**METROPOLITAN DEVELOPMENT COMMISSION  
HEARING EXAMINER**

**December 12, 2024**

- Case Number:** 2024-CVR-838 (Amended) / 2024-CPL-838A / 2024-CPL-838B
- Property Address:** 2451 – 2682 West 78th Street, 7649 – 7757 (odd) Diamond Street, 2822 – 2863 Emerald Street, 2801 – 2936 Moonstone Street, 2808 – 2863 Ruby Boulevard, and 7650 – 7740 (even) Walnut Drive (approximate addresses)

Approval of a Subdivision Plat, to be known as Augusta Heights, Phase 2, dividing 12.28 acres into 84 lots.

SHEET TITLE:  
 PRIMARY PLAT

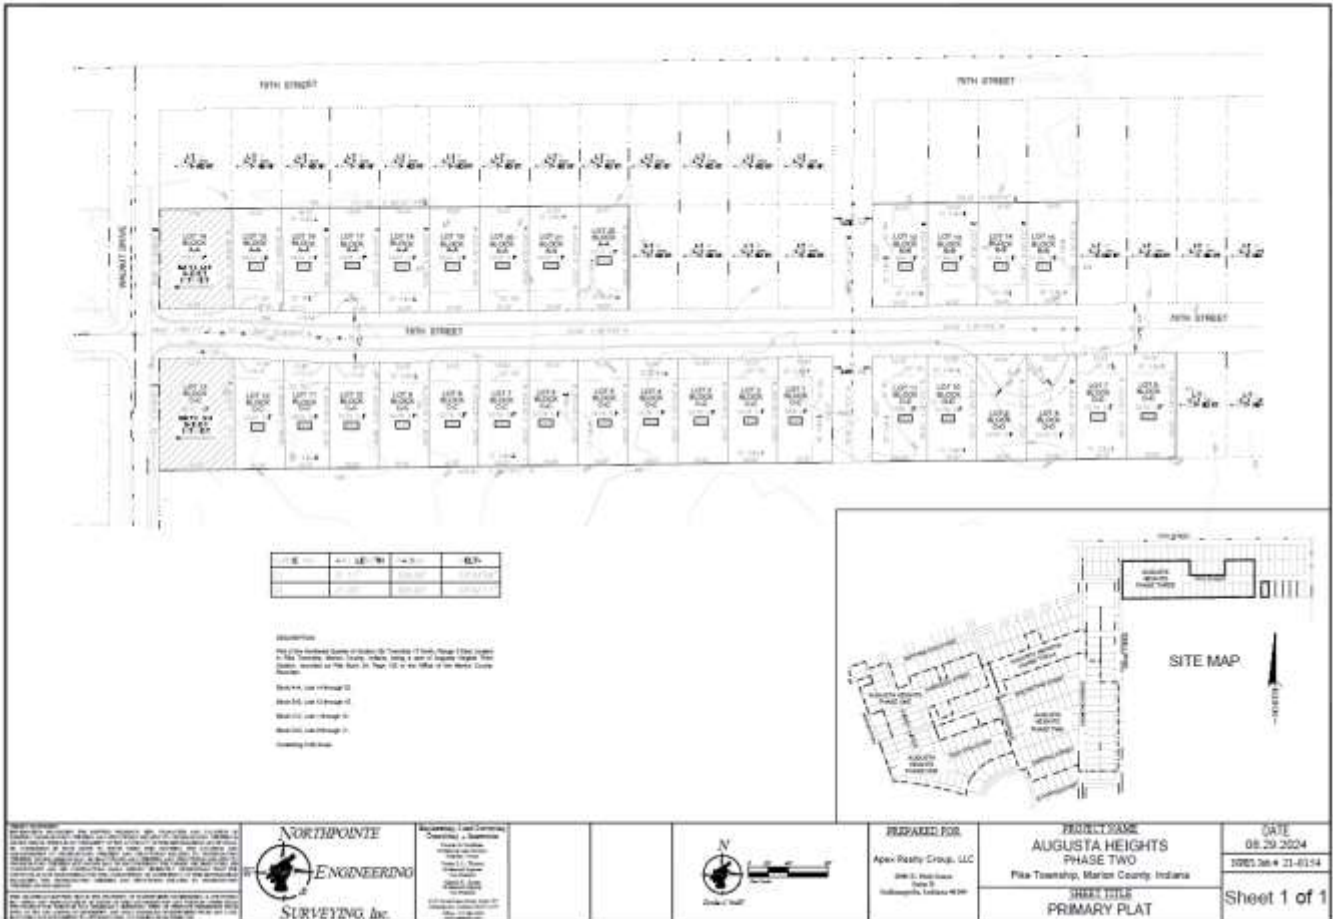
741.305 – Numbering and naming: <ul style="list-style-type: none"> <li>Street numbering per adopted addressing guidelines.</li> <li>Streets that are extensions or continuations of existing or approved streets must bear the name of such existing street.</li> </ul>	<b>Not Satisfied.</b>

741.306 – Sidewalks: <ul style="list-style-type: none"> <li>Sidewalks shall be provided along all internal and external streets.</li> </ul>	<b>Not Satisfied</b>

741.310 – Common Areas, Open Space and Public Sites (Compact Context Area): <ul style="list-style-type: none"> <li>Required for subdivisions with more than 20 dwelling units.</li> <li>Access easements shall be provided to connect all common areas to a public street right-of-way. The minimum width of such access must be at least 15 feet.</li> <li>Basic Open Space Requirements: Multi-purpose path, natural landscaping area, entrance landscaping.</li> <li>Additional Open Space Requirements: Community garden, dog park, game court, picnic area, playground, pool, etc. Additional component required for every 30 additional dwelling units overall.</li> <li>Reservation of land for public/semi-public purpose.</li> </ul>	<b>Not Satisfied.</b>	
741-312 – Monuments <ul style="list-style-type: none"> <li>Permanent reference monuments shall be placed in the subdivision by a Professional Surveyor. Where no existing permanent monuments are found, monuments must be installed no more than 600 feet apart in any straight line and in accordance with the schedule in Table 741-312-1.</li> </ul>	<b>Not Satisfied.</b>

<p>741.313 – Flood Control:</p> <ul style="list-style-type: none"> <li>• All development shall comply with all provisions of Section 742-203 (Flood Control Zoning District).</li> <li>• Floodway and Floodway Fringe zones shall be delineated and labeled on the primary plat and the plat to be recorded.</li> <li>• For Zone AE areas, the plat must show the BFE topographic line.</li> <li>• For Zone A areas, the plat must show the delineation study with the floodway and floodway fringe lines shown on the FIRM maps.</li> </ul>	<p>Satisfied</p>
	<p>741.316 – Street Lighting:</p> <ul style="list-style-type: none"> <li>• All subdivisions must be designed and constructed in accordance with the Street Lighting requirements of Section 744-600 (Street and Exterior Lighting).</li> </ul>	<p>Not Satisfied</p>

15. That all standards related to 741.305 – Numbering and naming be met prior to recording the final plat.
16. That an amended plat with sidewalks compliant with Section 741-306 of the Consolidated Zoning and Subdivision Ordinance be submitted prior to recording the final plat.

17. That all standards related to 741.310 – Common Areas, Open Space and Public Sites (Compact Context Area) be met prior to recording the final plat.
18. That a Monumentation plan compliant with Section 741-312 of the Consolidated Zoning and Subdivision Ordinance be submitted prior to recording the final plat.

19. That a street lighting plat compliant with Section 741-316 of the Consolidated Zoning and Subdivision Ordinance be submitted prior to recording the final plat.
